Outer Dowsing Offshore Wind

Offshore Reactive Compensation Platform Physical Processes Assessment Clarification Notes

Document Reference: 27.7

2 ORCP Physical Processes Clarification Note 1 dated 19th May 2025

Figure 1 Location of the Offshore Reactive Compensation Platform and the Inner Dowsing Sandbank

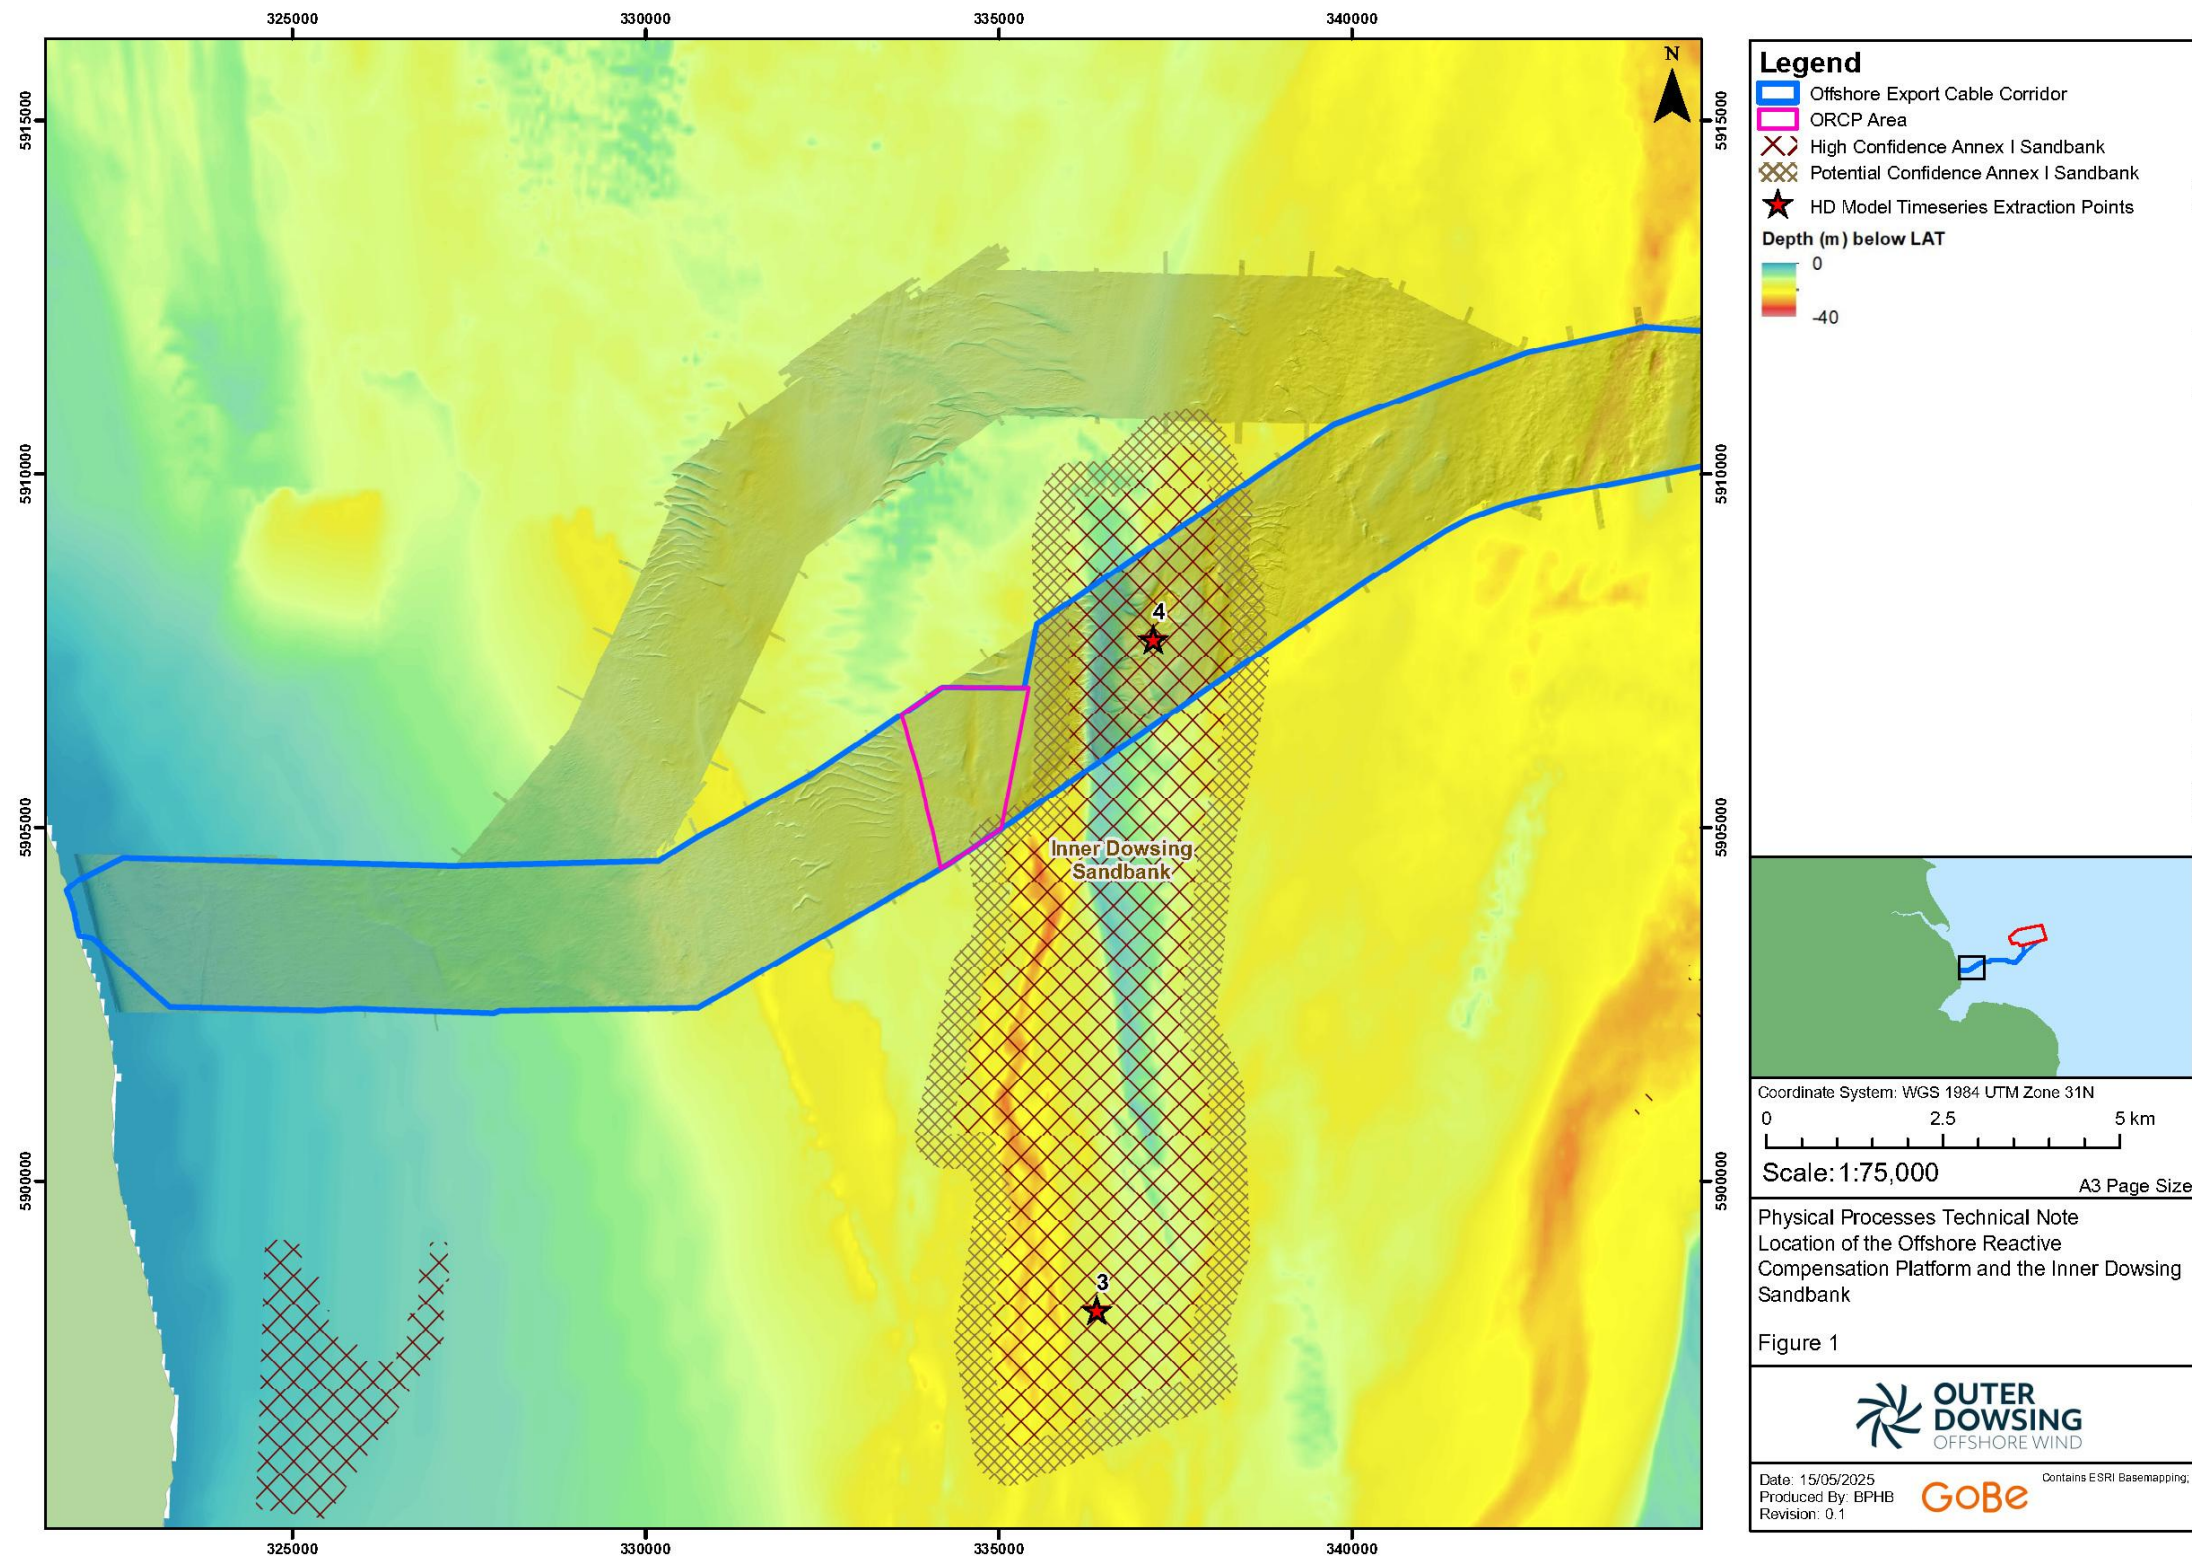
3. Natural England have outlined the following concerns within Appendix B5 – Natural England’s Advice on Marine Processes regarding the Proposed ORCP Area at Deadline 6:

- That the presence of the ORCPs adjacent to the Inner Dowsing, Race Bank and North Ridge (IDRBNR) Special Area of Conservation (SAC) and Inner Dowsing sandbank could modify waves, hydrodynamics and sediment transport and in turn lead to morphological change to Annex I interest features within the SAC;

- That more detailed information is needed to support the Applicant’s conclusions;
 - That all mitigation options should be explored, following update to the bedform migration assessment, and these options could include (but not exclusively) consideration for siting the ORCPs as far to the west of their ORCP area (thereby increasing their distance from the SAC/sandbanks to the east); and

- That currently indirect impacts which could hinder the conservation objectives of IDRBNR SAC cannot be excluded; and without further evidence Natural England are unable to advise further on the scale and significance of these impacts.

10. Full details of the numerical modelling assumptions including the parameters, data sources and calibration/validation details are provided in Appendix 7.1 (AS-003) Annex B and Appendix 7.2 (APP-151). Numerical wave and tidal blockage modelling was informed by a range of data sources including pre-construction geophysical survey data covering the Offshore ECC (GEOxyz, 2022), as shown in Figure 1, which provided bathymetric data with a resolution of 0.25m.

13. The Maximum Design Scenario (MDS) for wave and tidal blockage has been outlined in Table 7.3 of Chapter 7 (REP4a-042). This included two slab-based ORCP foundations located within the ORCP area (Figure 1) with a minimum separation distance of 90m apart. It should be noted that this modelling represents a conservative scenario for the ORCPs, for which the GBS option has been removed as of Examination Deadline 4a. Suction bucket jacket foundations (now the proposed design option for the ORCPs) have a smaller surface area in the water column than GBS foundations and therefore provide less interruption to hydrodynamic flows (ICF, 2020). This is demonstrated by the comparison of normalised blockage factors presented within Appendix 7.1 (AS-003) Annex B.

15. The ORCP area is located along the offshore ECC to the west of the Inner Dowsing sandbank, as shown on Figure 1, in water depths of between 10m and 20m (Lowest Astronomical Tide (LAT)). The Inner Dowsing sandbank is located within the IDRB NR SAC, and is understood to be a relict feature with a veneer of sand bedforms maintained by tidal currents (JNCC, 2010). Evidence provided in Centrica (2007) suggests that although the Inner Dowsing bank has experienced some changes in crest level, as indicated by changing contour lines between successive historic charts, it remains broadly in the same position and alignment. This is further corroborated by the classification of Inner Dowsing as “Moribund/Relict”² within Natural England Commissioned Report NECR550 (Reach *et al.*, 2025).

Figure 1 Location of the proposed Offshore Reactive Compensation Platform Restriction Area

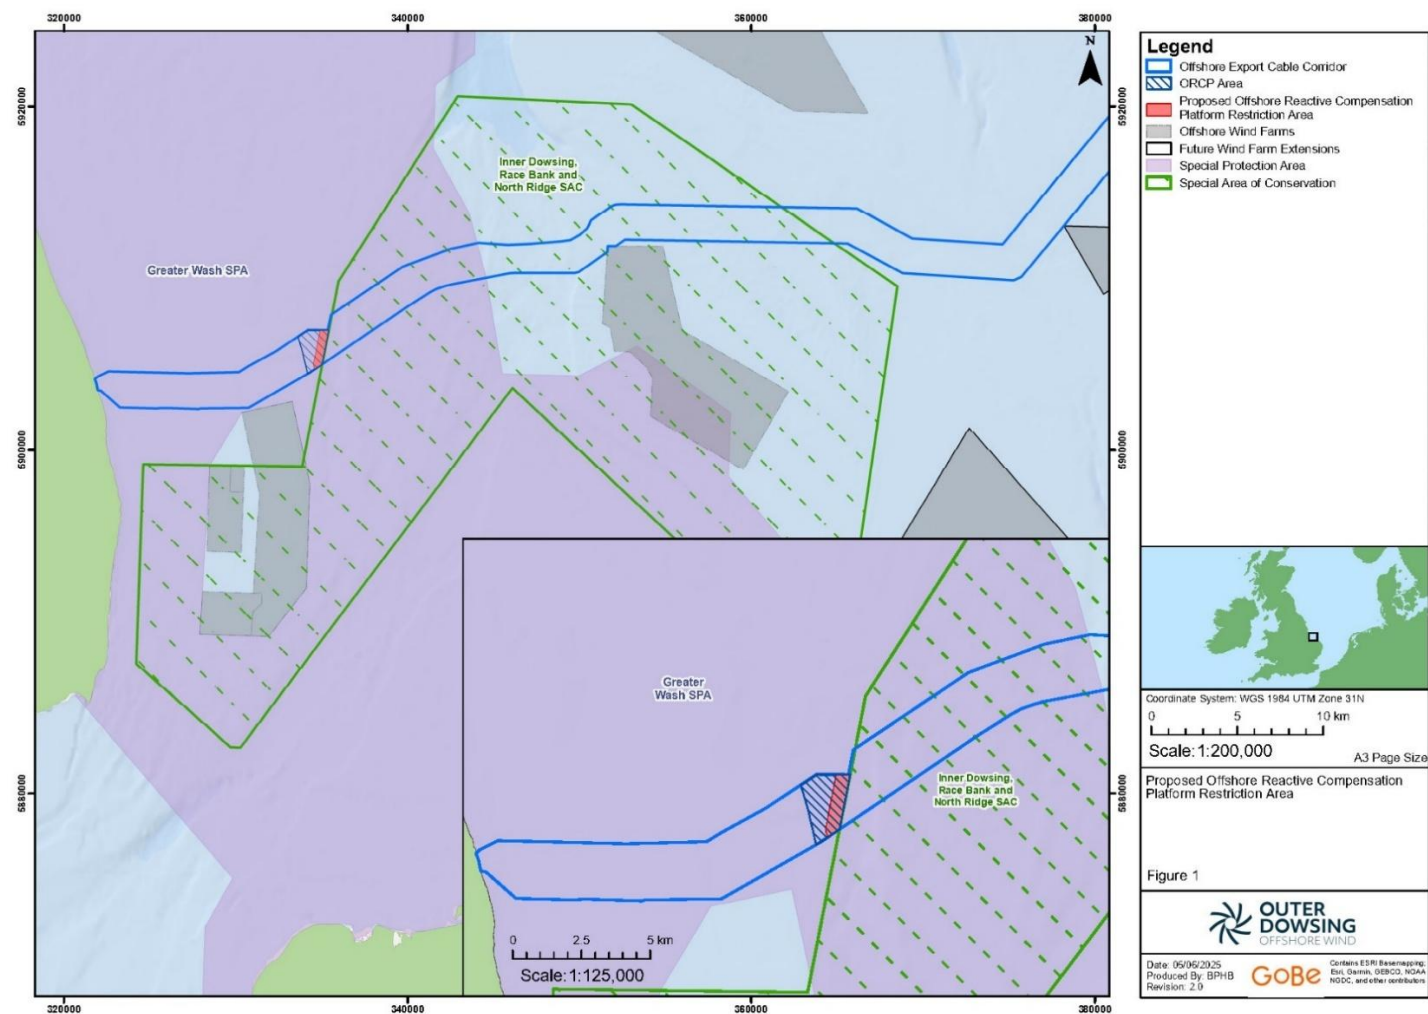
- That further consideration needs to be given to the potential effect of sandbank migration (due to evidence of sandbank migration provided in the Seabed Mobility Study (APP-152)) and resulting interactions between the ORCP structures and the migrating sandbank-sandwave system.

- 15 Following the close of Examination, the Applicant met with Natural England on the 11 June 2025 to discuss the remaining concerns. Whilst the Applicant maintains that there is no pathway for effect to the SAC, Natural England's concerns are acknowledged. In response to Natural England's advice that all mitigation options should be explored including the siting of the ORCPs further west within the ORCP area, the Applicant proposed the implementation of an ORCP Restriction Area. This area establishes a 500m zone between the ORCPs and the IDRBNR SAC boundary within which no ORCPs can be constructed (see Figure 1). This reduces the ORCP Area from 3.00km² to 1.92km².

- 16 Natural England agreed that the proposed ORCP Restriction Area provides suitable confidence that there would be no AEoI on the IDRBNR SAC over the project's operational lifetime. However, they raised concerns regarding potential impacts beyond the operational lifetime, particularly in relation to the possible westward migration of the sandbank feature. This reflects submissions made within Appendix B5 – Natural England's Advice on Marine Processes regarding the Proposed ORCP Area ([REP6-159](#)) at Deadline 6, where Natural England highlight estimates of potential sandbank migration presented in the Seabed Mobility Report (Table 6.1) and advise further consideration of the potential effect of sandbank migration.

Figure 2 Hydrodynamic Blockage Effects

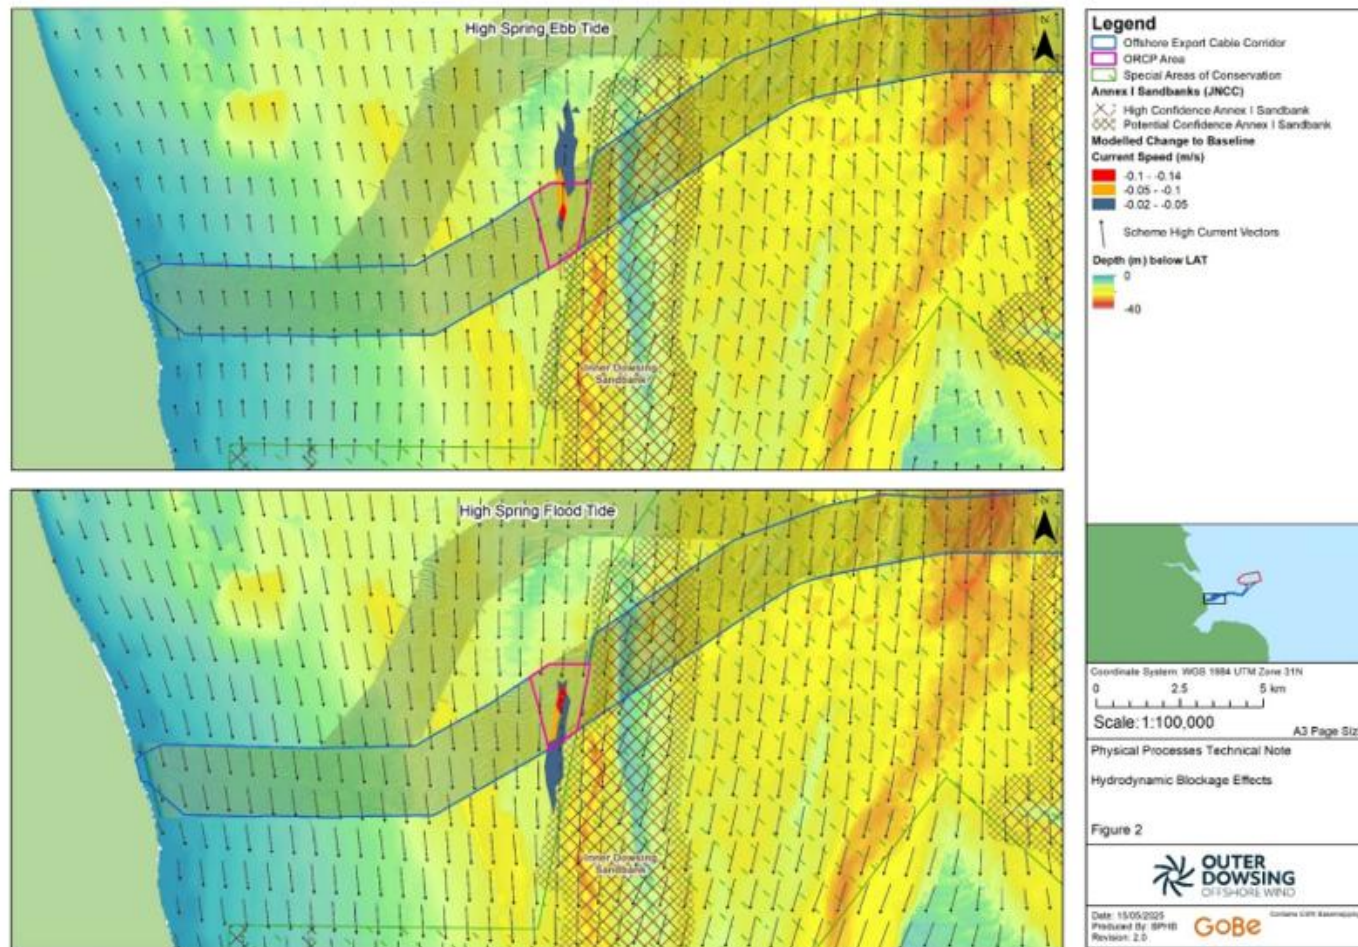
- That the presence of the ORCPs adjacent to the Inner Dowsing, Race Bank and North Ridge (IDRBNR) Special Area of Conservation (SAC) and Inner Dowsing sandbank could modify waves, hydrodynamics and sediment transport and in turn lead to morphological change to Annex I interest features within the SAC;

- 11 This is supported by the numerical model results, which show that any change to the regime parameters occurs towards the north and south (for tidal currents; Figure 2) and towards the south-west (for waves; Figure 3), as well as the sediment mobility analysis provided in Chapter 7 (REP4a-029) Annex A. Localised current speed reductions of up to 0.14m/s may occur during high current conditions. However, these changes are limited in both spatial and temporal extent, and are not directed towards the sandbank to the east. Similarly, the results of the wave blockage modelling demonstrate that the wave shadow will not propagate eastward.
